ATTACHMENT 1

Marked Up Technical Specifications Pages

Safety Evaluation

This amendment request is in support of Callaway Refuel 8. During Refuel 8, fuel that does not meet the current IFBA versus enrichment limit of FSAR Figure 9.1A-4 and Technical Specification 5.3.1 is planned to be loaded into the core. This amendment request proposes to modify Technical Specification section 5.3.1 to reflect a change in the maximum initial enrichment to 5.0 w/o U-235 for reload fuel and a change to the maximum fuel enrichment without requiring integral fuel burnable absorbers (IFBAs) for storage in Region 1. We also request that Technical Specification section 5.6.1.1 be revised to reflect a change in the maximum reference  $K_{\infty}$  from 1.455 to 1.480 for storage in Region 1 of the Spent Fuel Pool. Technical Specification Figure 3.9-1 is also to be revised to reflect a maximum initial enrichment of 5.0 w/o for storage in Region 2.

FIGURE 3.9-1  
MINIMUM REQUIRED FUEL ASSEMBLY BURNUP AS A FUNCTION  
OF INITIAL ENRICHMENT TO PERMIT STORAGE IN REGION 2

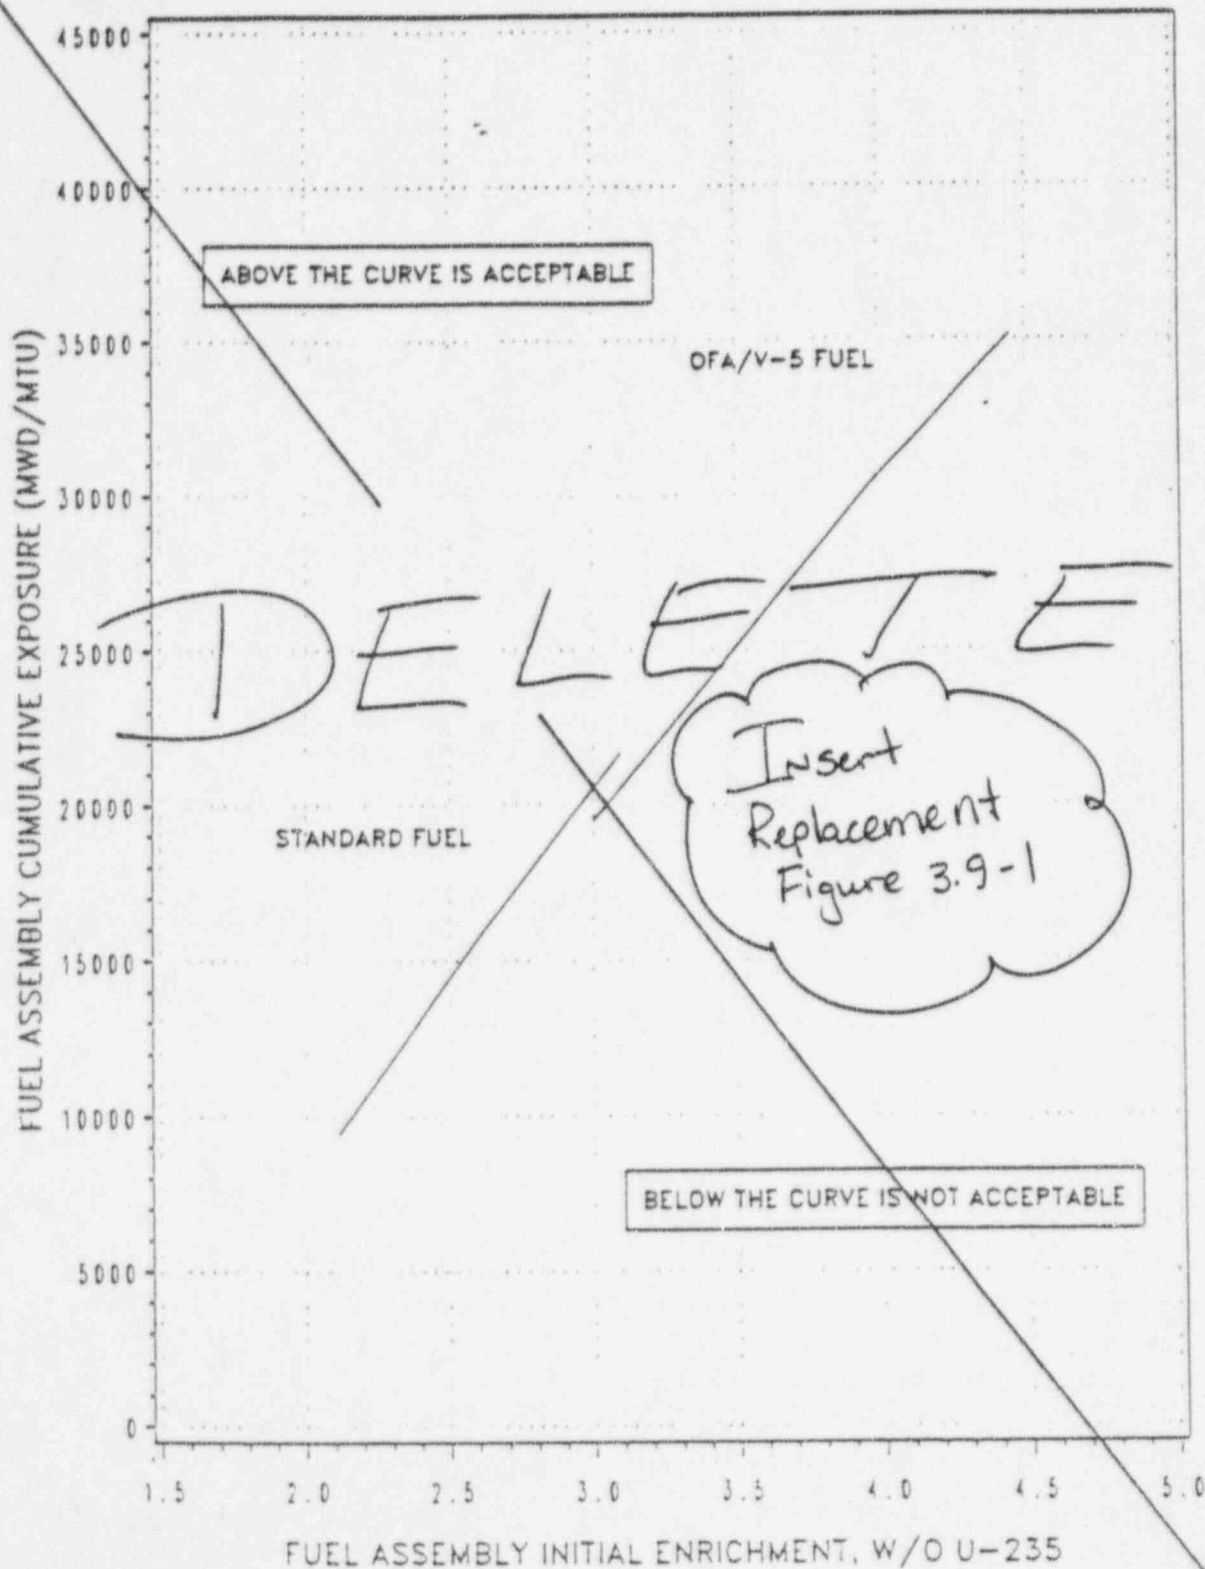
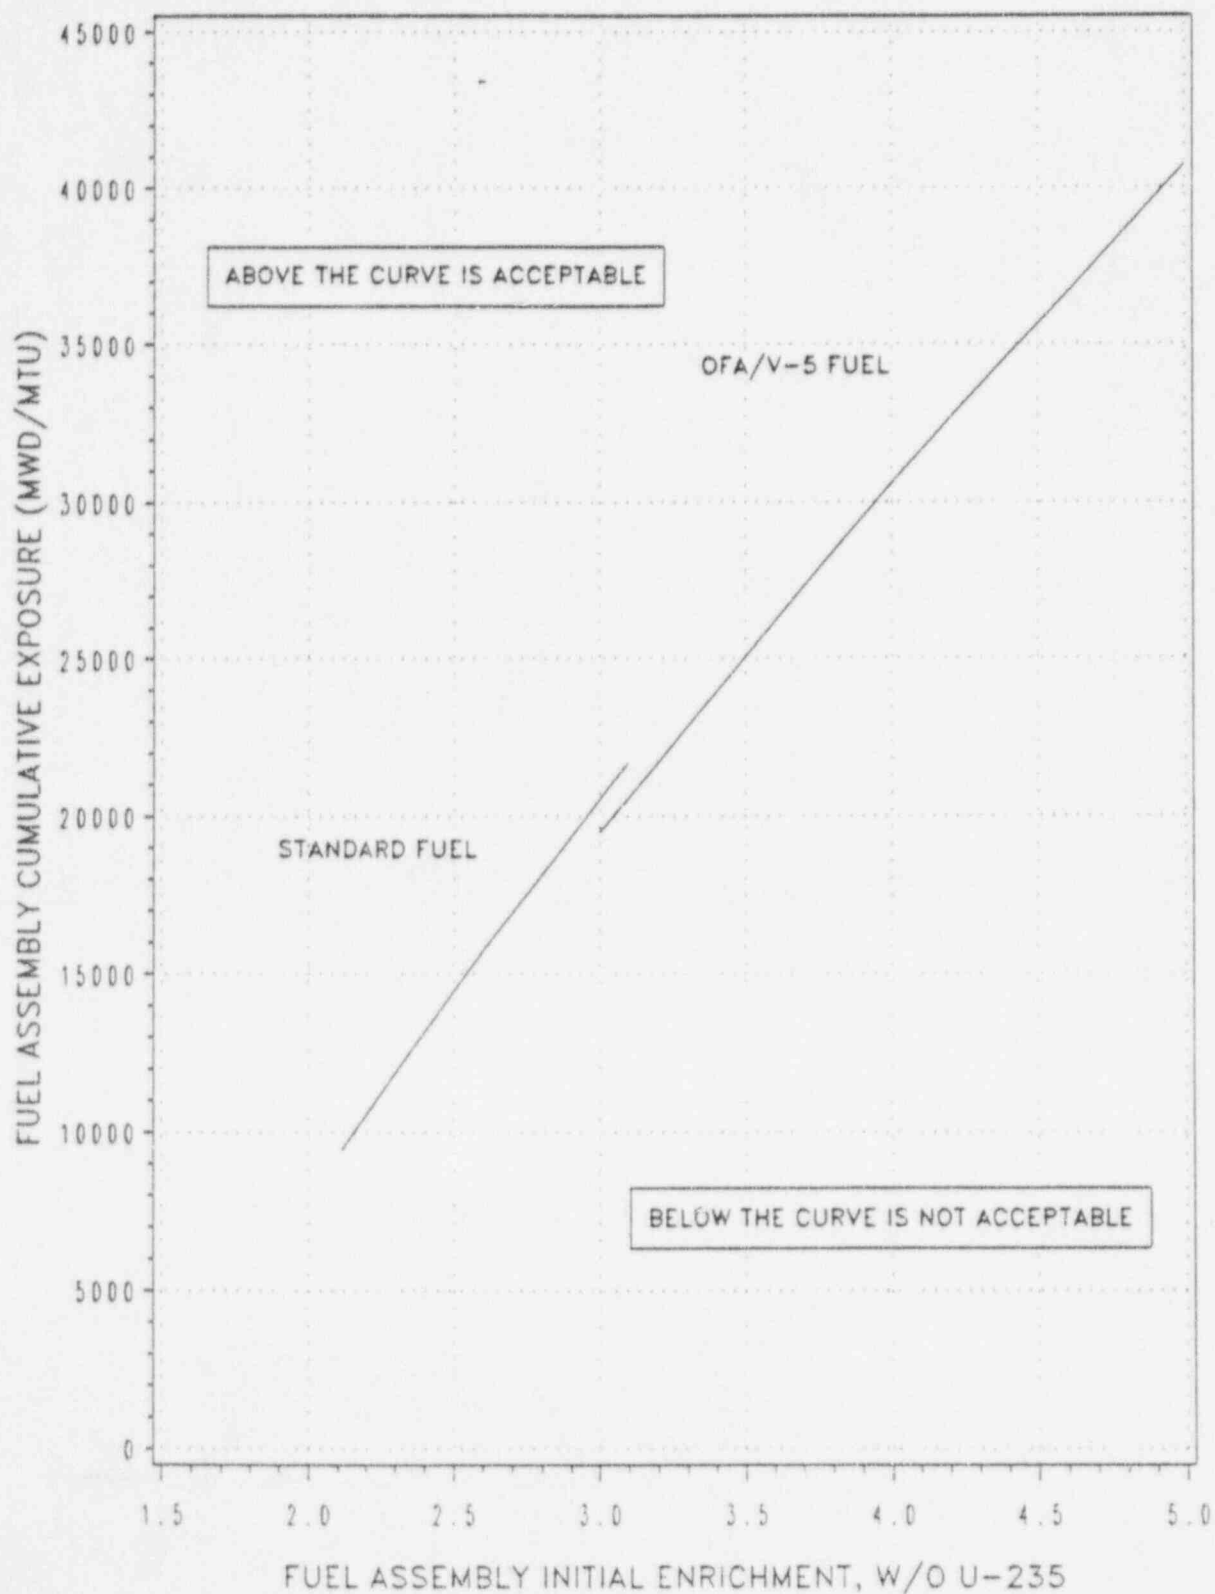
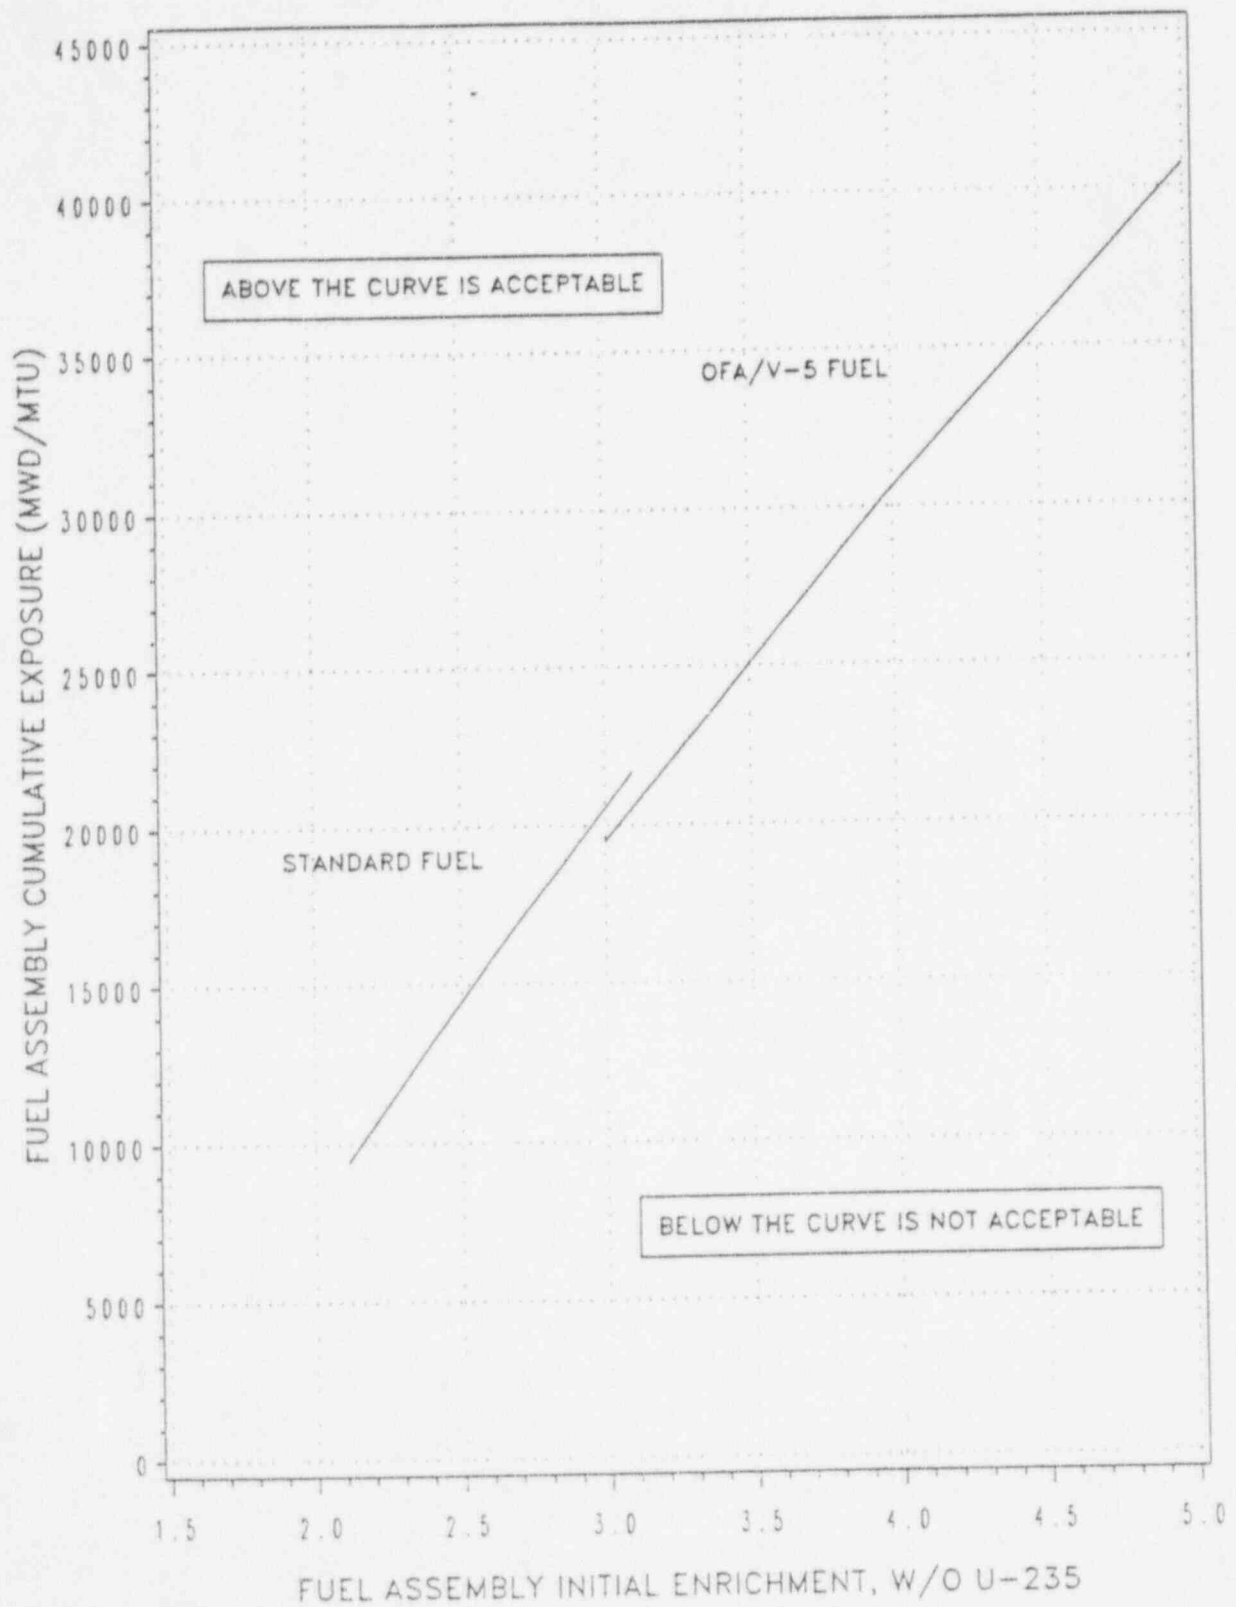
Previously approved analyses performed to support the storage of higher enrichment fuel in Region 2 of the Callaway spent fuel pool concluded that spent fuel criticality limits are maintained when storing fuel to a maximum initial enrichment of 5.0 w/o U-235, provided that the fuel burnups meet the prescribed limits (reference ULNRC-2647, dated June 12, 1992). The previous amendment only addressed fuel enrichments up to 4.45 w/o U-235 due to thermal/hydraulic constraints. These constraints have been resolved and the current spent fuel pool heat load methodology can be used to support storage of fuel up to a maximum initial enrichment of 5.0 w/o U-235. However, cycle specific decay heat load analyses will still be required.

FIGURE 3.9-1  
MINIMUM REQUIRED FUEL ASSEMBLY BURNUP AS A FUNCTION  
OF INITIAL ENRICHMENT TO PERMIT STORAGE IN REGION 2
